## **Proposal for Supplement 1 to UN Regulation No. 151 (Blind Spot Information Systems (BISIS))**

### **Submitted by the experts from the Working Party on General Safety\***

## Supplement 1 to UN Regulation No. 151 (Blind Spot Information Systems (BISIS))

Appendix 1, Figure 1, amend to read:

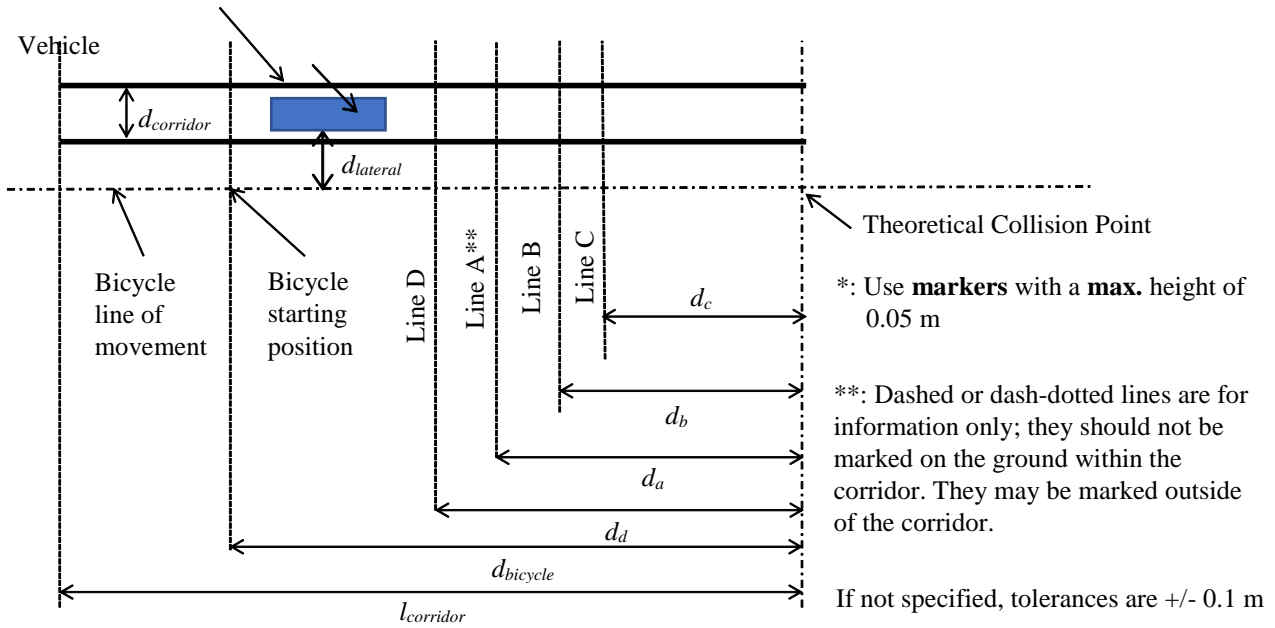
Mark corridor using markers \*, spacing not more than 5 m
